Oregon Roof Consulting and Inspection

Roof Inspection for:

I inspected this roof on July 31st 2023. I met the owner, looked in the attic and got on the roof. The roof is a new GAF 'Timberline' 30 year factory warranted asphalt laminated shingle. One layer over plywood. Separate photo emails will be sent. Each photo email will be numbered to correspond to the numbered items on the summary report. The following items should be noted:

NAILING INSTRUCTIONS / HAND SEALING INSTRUCCIONES DE CLAVADURA / SELLADO A MANO INSTRUCTIONS DE CLOUAGE / SCELLEMENT À LA MAIN

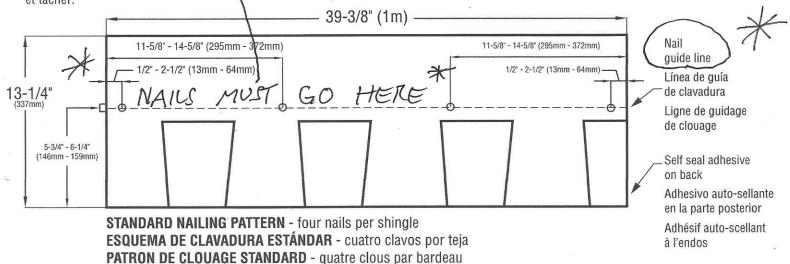
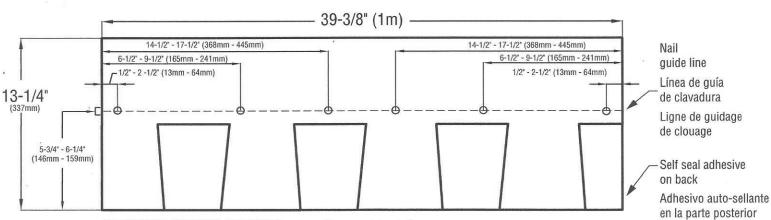
- 5. The ridge vent opening is way too small. There must be a 3/4" cut on both sides of the apex / peak.
- 6. The nails used to fasten the shingles are too high and a majority are over driven. Laminated shingles are 2 pieces: A 'blank' and a 'sawtooth'. Where they overlap has a factory embossed line or lines which is the nailing 'line' or 'zone'. This is the strongest part of the shingle and is where the nails must go. Most nails I saw were above the nailing line and most of those are also over driven. Nails must be driven straight with heads flush with the shingle surface.

These shingles MUST be nailed a nominal 6" (152mm) from bottom of shingle, above the cut-outs, as shown. Nails must not be exposed. To hand seal and to insure immediate sealing, apply 4 quarter-sized dabs of shingle tab adhesive on the back of the shingle 1" (25mm) and 13" (330mm) in from each side and 1" (25mm) up from bottom of the shingle. Press shingle firmly into the adhesive. **CAUTION:** Apply ONLY a thin uniform layer of as halt plastic cement less than 1/8" (3mm) thick. Excess amounts can cause blistering of the shingles and may soften the asphalt in underlayments and leak barriers, resulting in the asphalt dripping and staining.
